V2_Grading & Erosion Control Plan_COMMENTS.pdf Markup Summary

PCD File PPR265

ASCENT CHURCH

STORM PNP

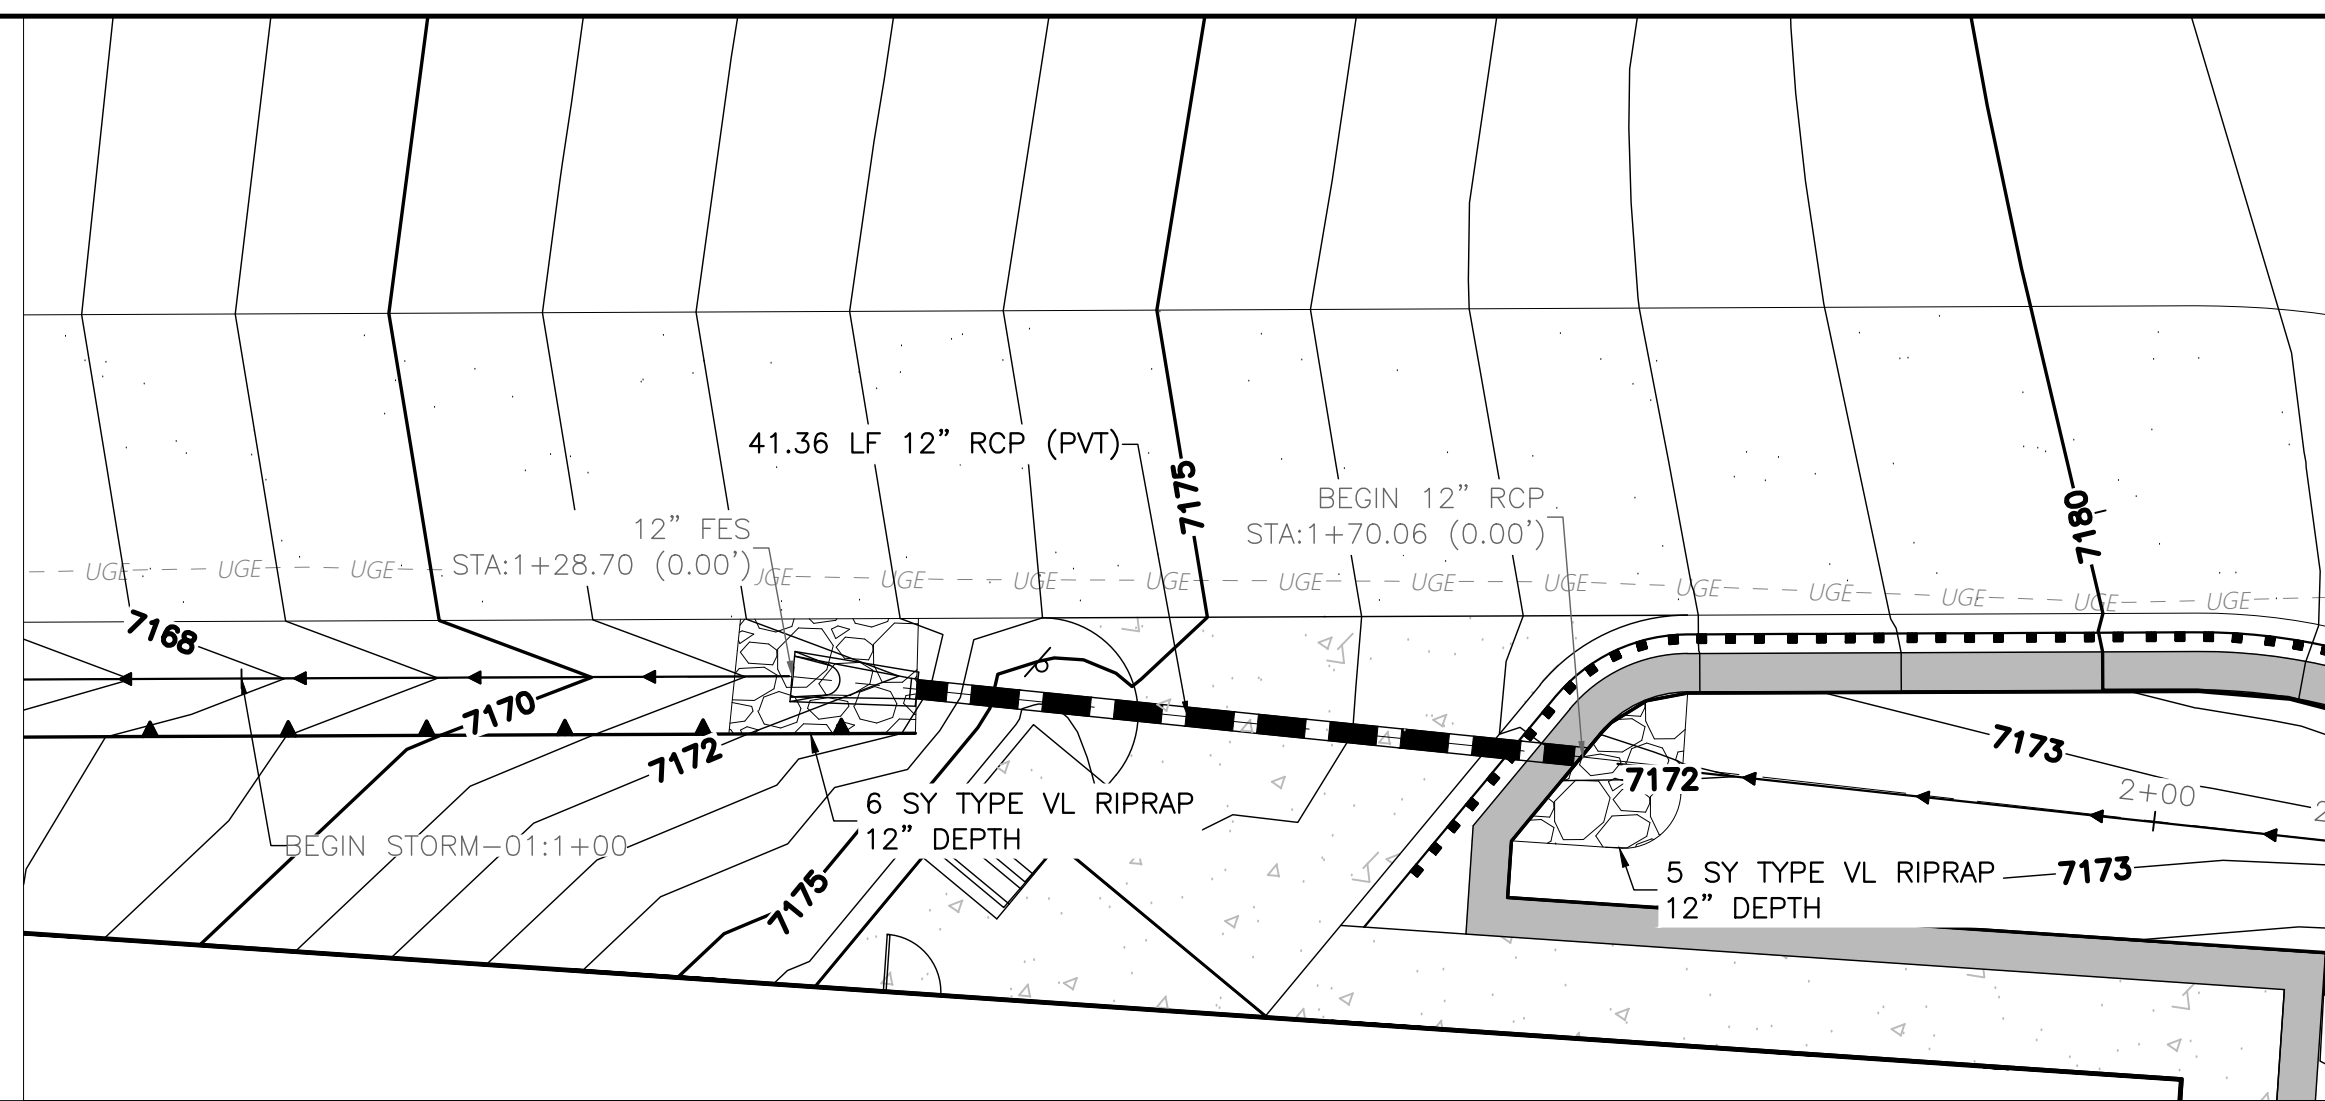
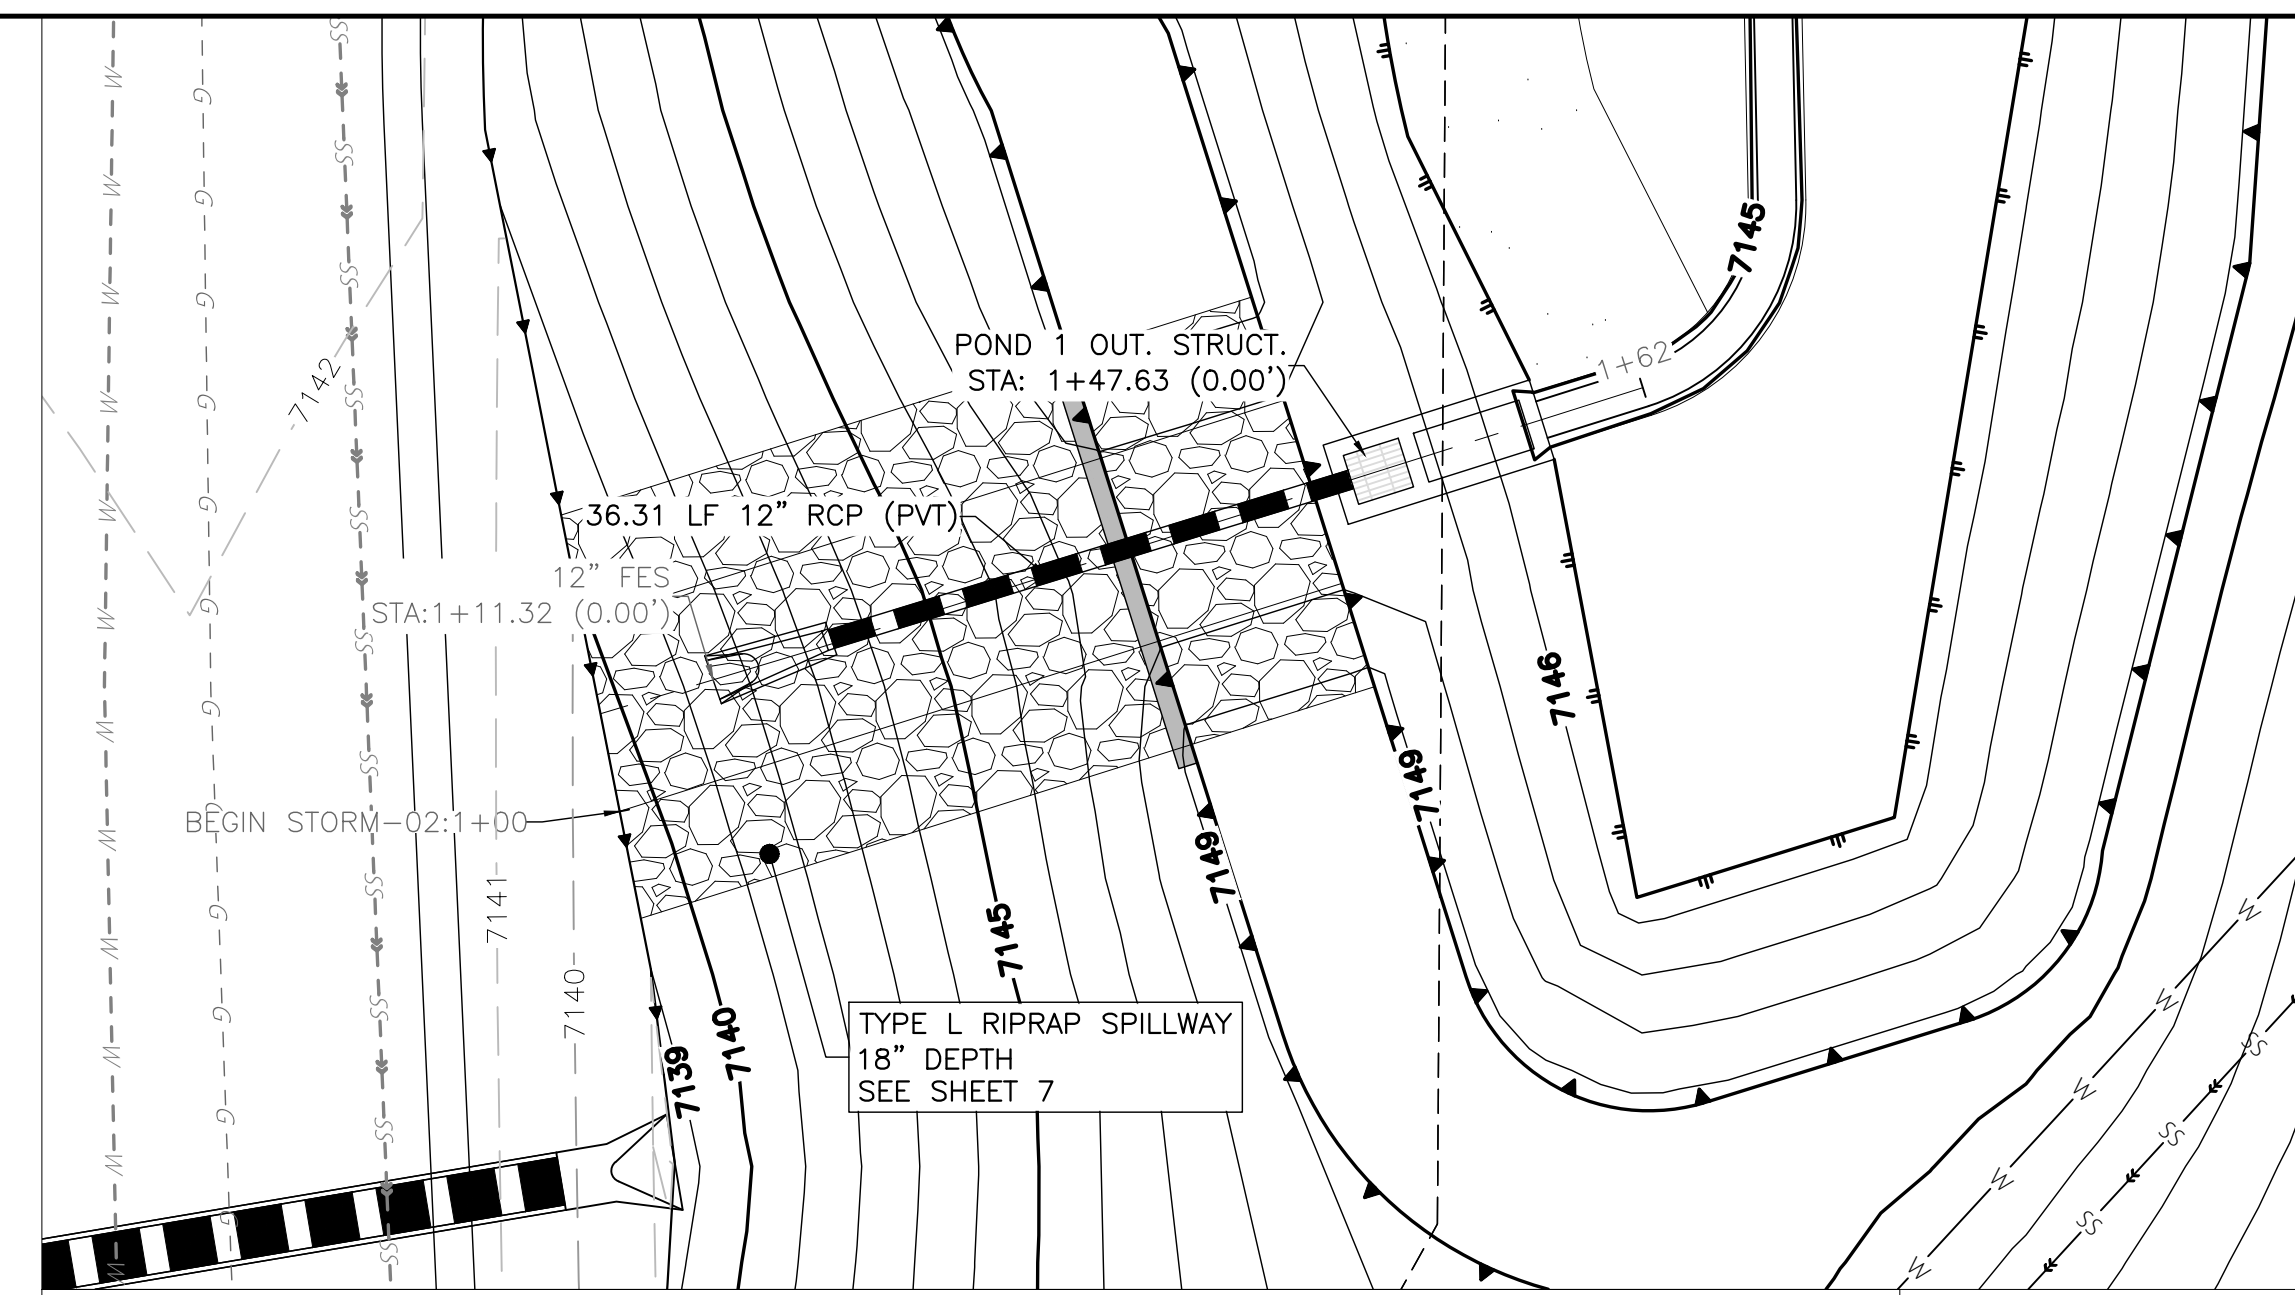
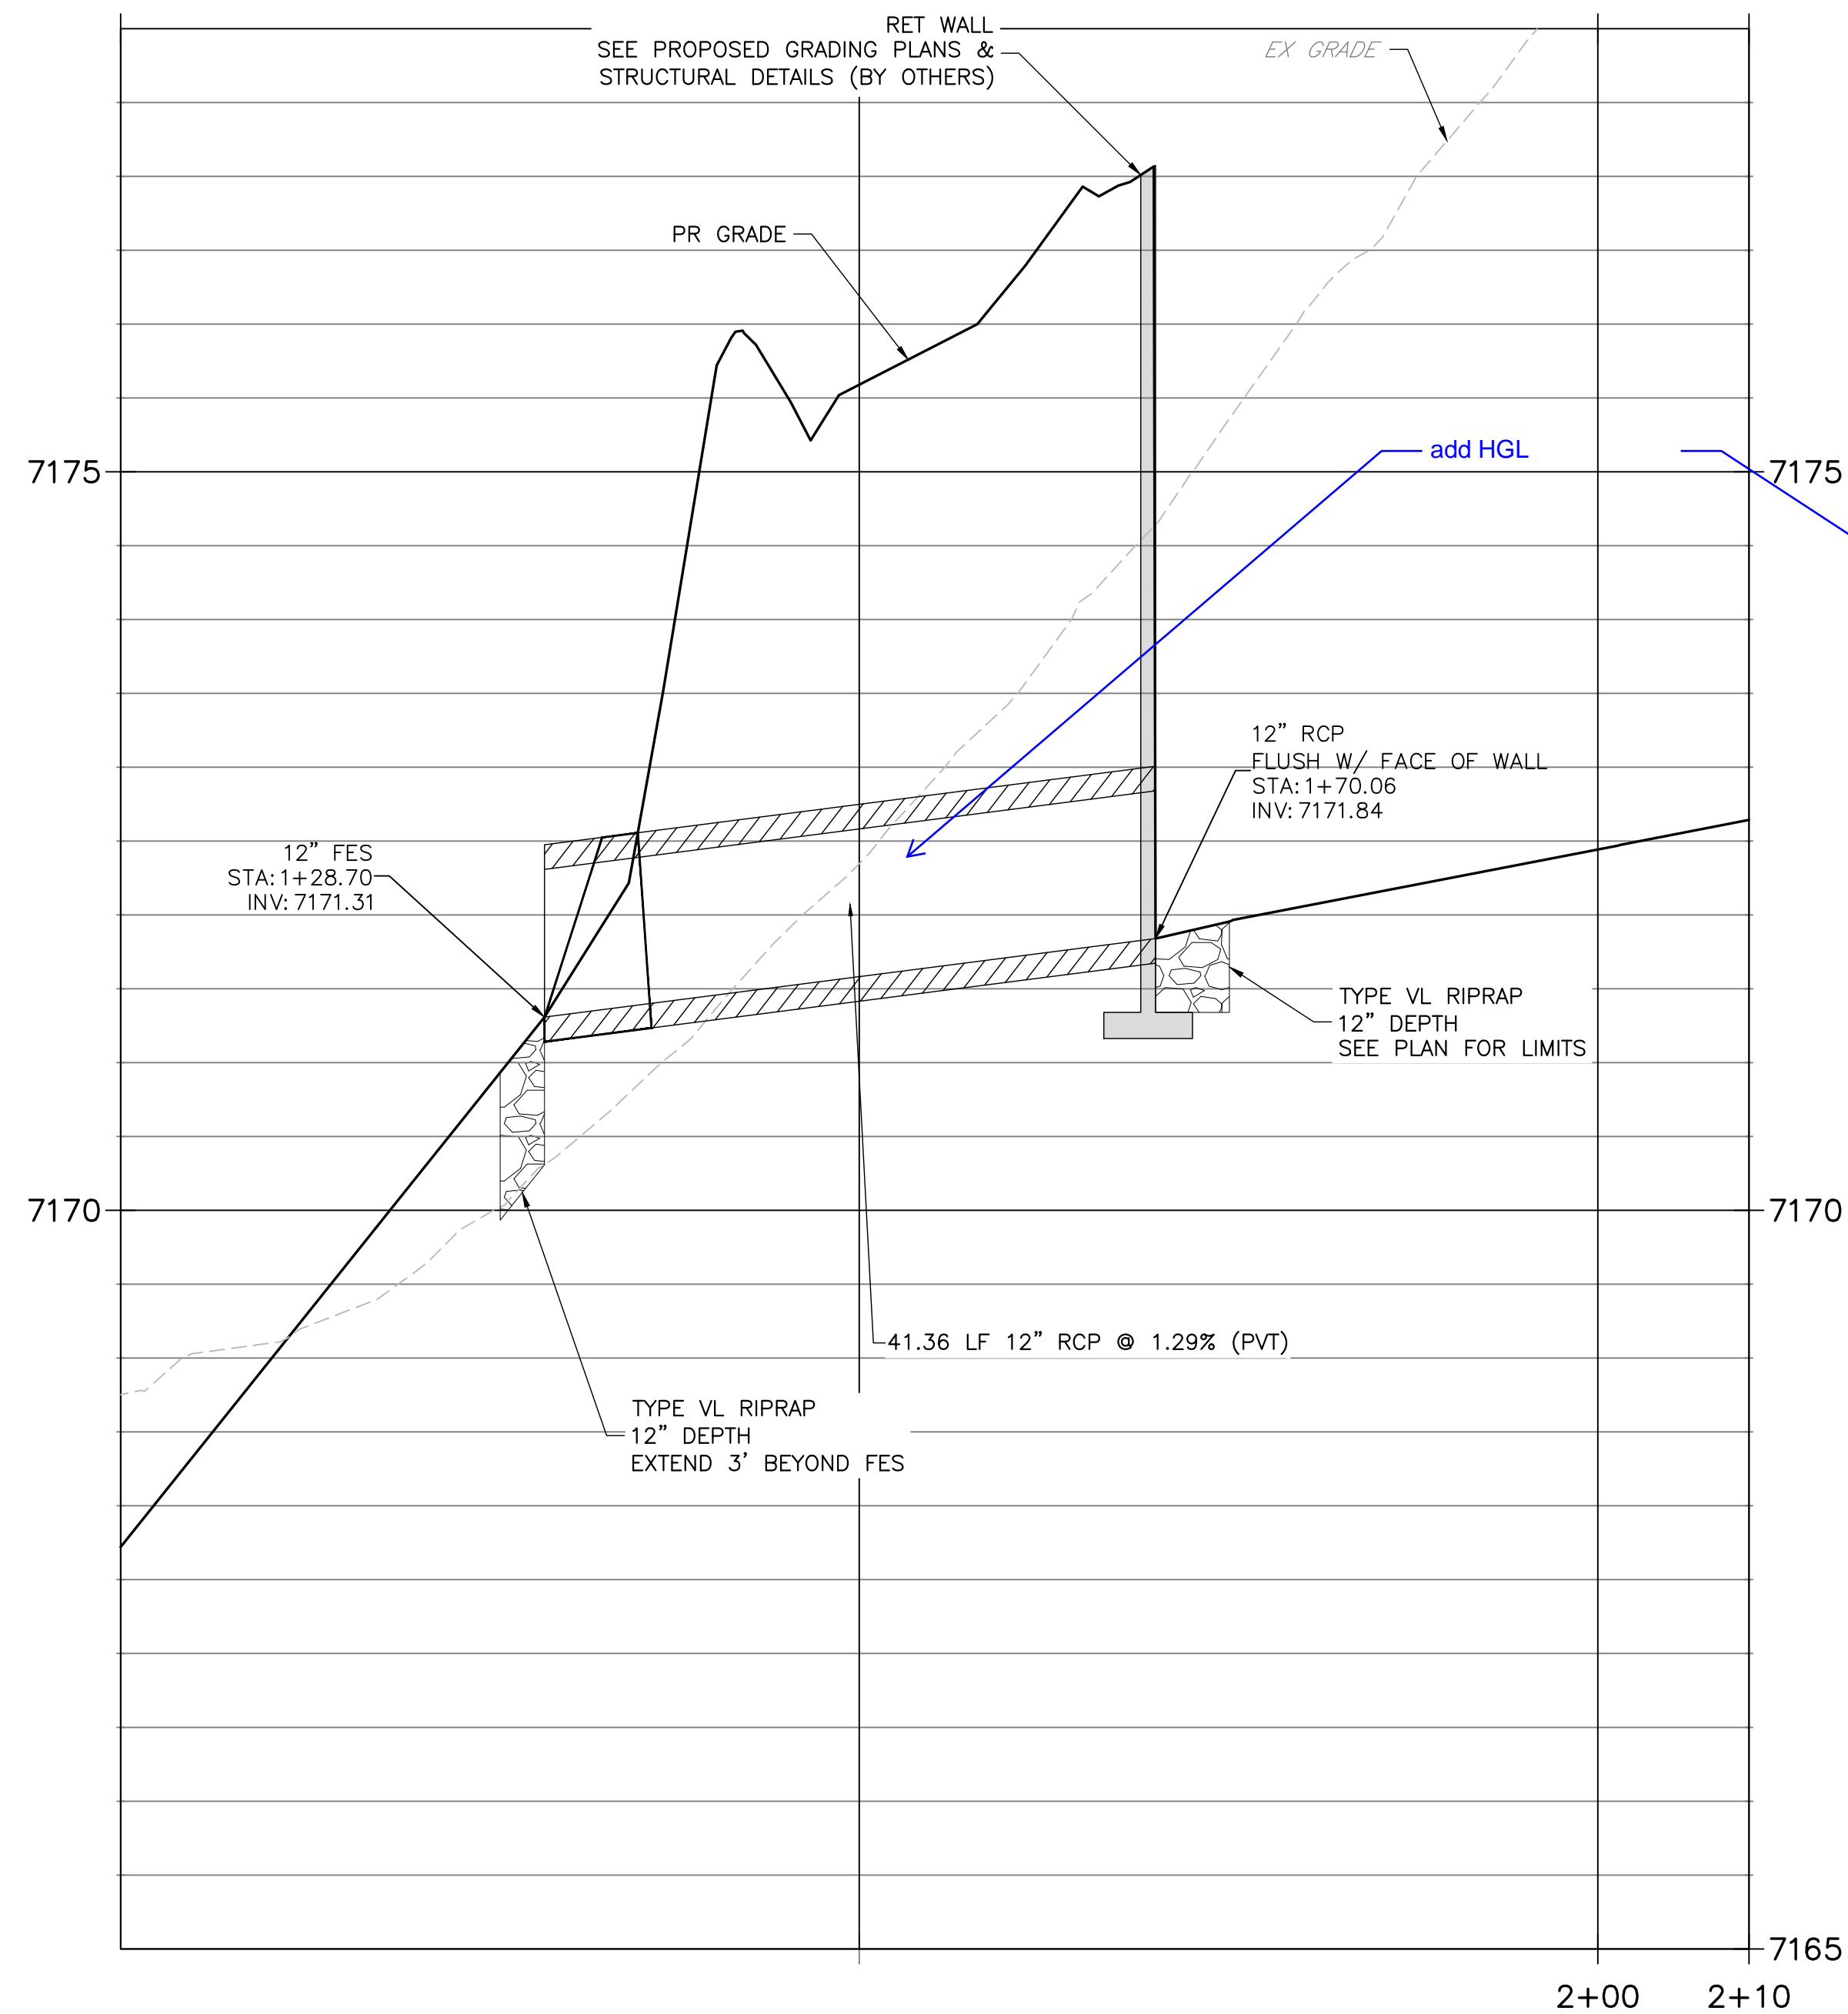
add HGL
